FINAL DRAFT MINUTES

January 19, 2023 Standards Committee Meeting

RE: Minutes from the January 19, 2023 Standards Committee Meeting

E 714-BCJT-01 PRECAST REINFORCED CONCRETE SECTION JOINTS (WITH MARKUPS)

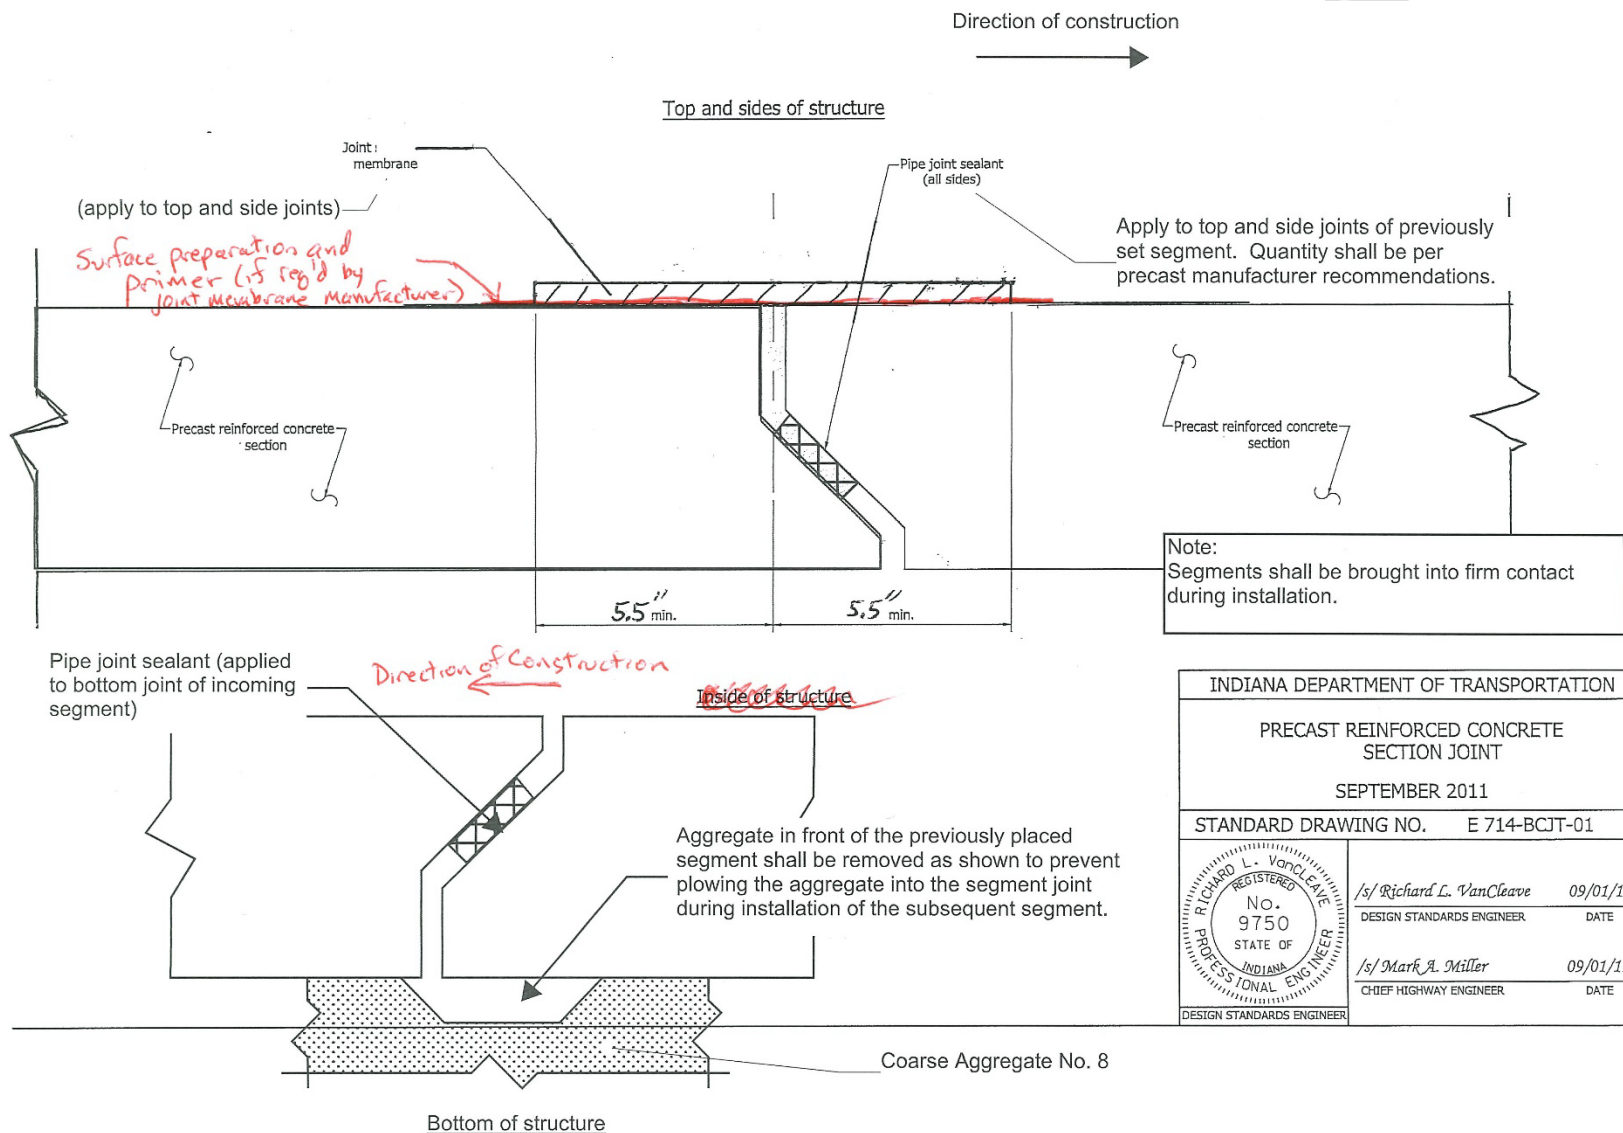
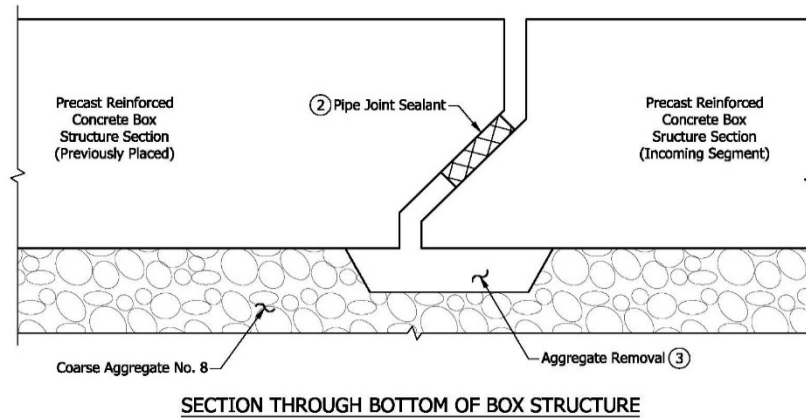
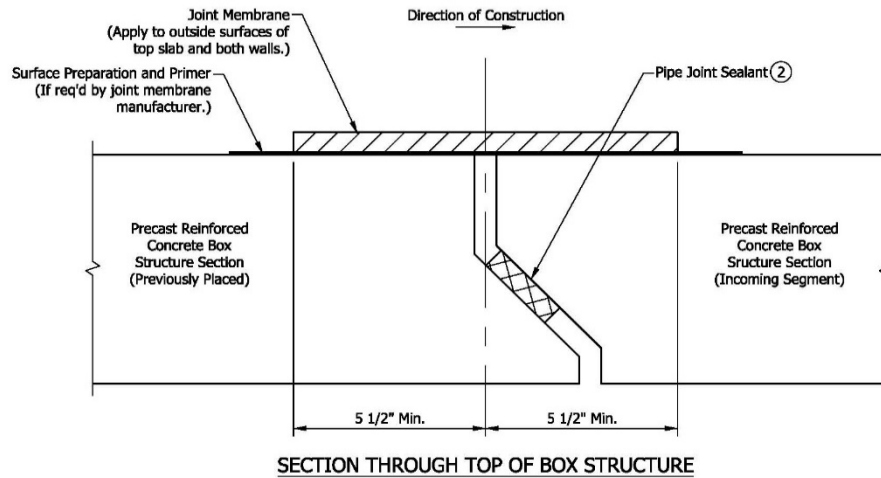
PROPOSED SOLUTION: Incorporate the proposed changes which clarify the material(s) to be placed between joints in precast concrete box and three-sided culvert sections. Also clarify and update the material used to wrap the exterior of the joint shall be in accordance with an ASTM spec.

Mr. Reilman proposed to incorporate the proposed changes which clarify the materials to be placed between joints in precast concrete box and three-sided culvert sections. Also clarify and update the material used to wrap the exterior of the joint shall be in accordance with an ASTM spec.

Mr. Koch asked, with regard to 714.10(b) and 723.14(b), where it states “both sides of every joint”, for added clarity should ‘exterior’ be added?

Mr. Reilman responded that we do have standard drawings to accompany the 714 and 723 revisions. However, I agree with you in that “exterior” could be added as you note below for added clarity.

Language was revised for clarification and Mr. Reilman revised his motion. Mr. White seconded the motion.

E 723-TSJT-01 PRECAST REINFORCED CONCRETE THREE-SIDED STRUCTURE SECTION JOINT (PROPOSED DRAFT)

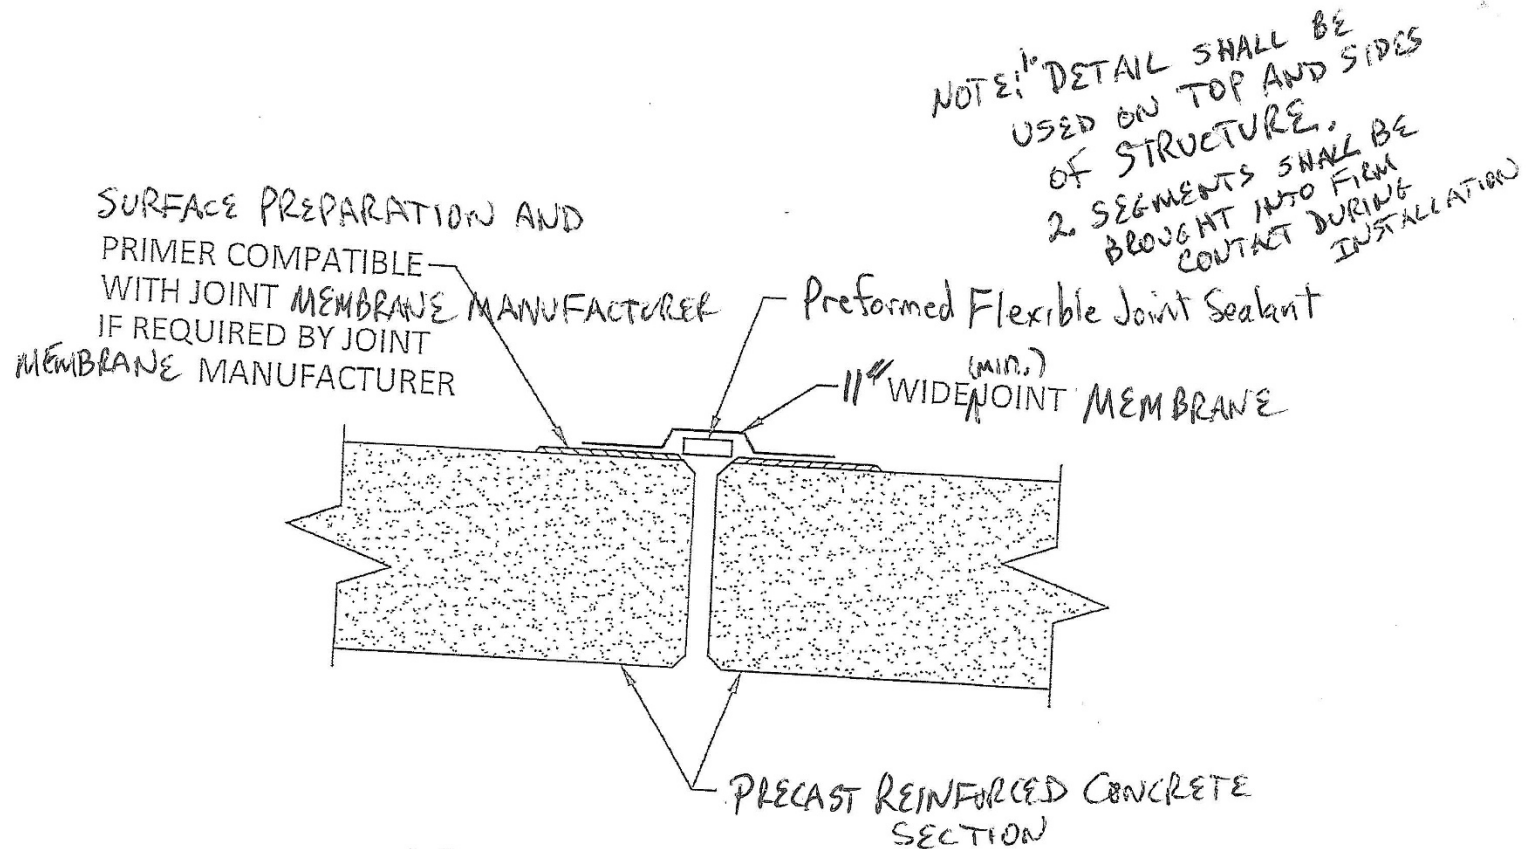
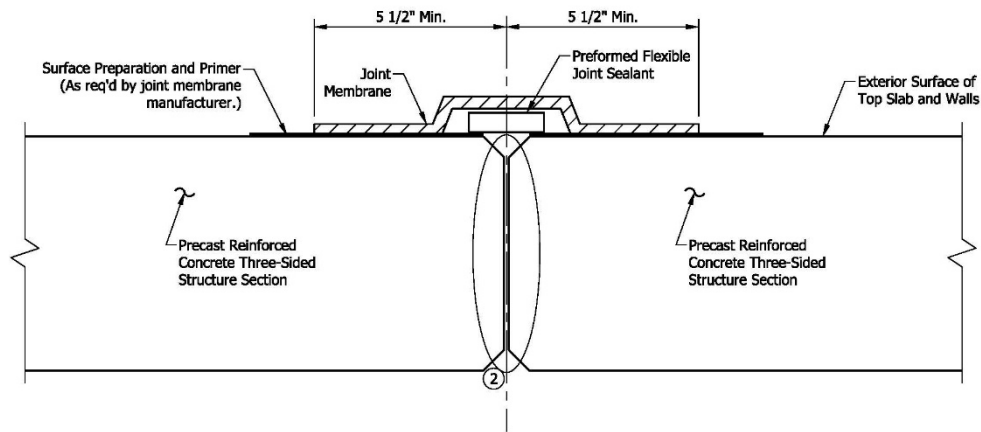
Outside of the meeting, Steve Smart asked about Note 2 on the standard drawing for the three-sided structures (Segments shall be brought into firm contact during installation). Mr. Smart asked “what is INDOT’s expectation of firm contact?”. Mr. Reilman responded that the expectation is that the sections will be pushed together as much as possible until they no longer move.
